TECHNICAL BULLETIN

POINT BLANK 2

Two problems have been identified on games with the following serial numbers:-

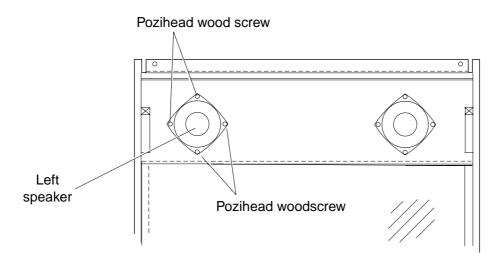
The loudspeakers have been wired 'out of phase' resulting in a loss of bass tone.

3. Remove 4off pozi head wood screws and remove the left speaker only sufficiently to access the speaker connections.

- 4. Disconnect the speaker.
- 5. Cut off the 0.110" (smallest) receptacle from the white/violet wire and replace it with the supplied 0.187" receptacle.
- 6. Cut off the 0.187" receptacle from the white/red wire and replace it with the supplied 0.110" receptacle.
- 7. Reconnect the speaker and reassemble in reverse order.

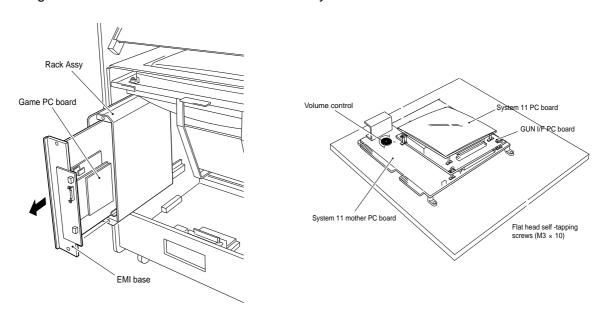
The master volume has been set too low.

- 8. Open the back door and disconnect the connectors from the EMI Board.
- 9. Remove 2off pozi head screws (M5x12) from the rack assembly, taking care not to lose the toothed washer behind the earth terminal.

10. Carefully withdraw the game pcb assembly from the rack assembly only sufficient to gain access to the volume control on the System 11 Mother PC Board.

- 11. Turn the volume control clockwise to approx 3/4 of its travel.
- 12. Ensure that the System 11 Mother PC Board edge connection is fully seated in the edge connector housing of the EMI PC Board and reassemble in reverse order.
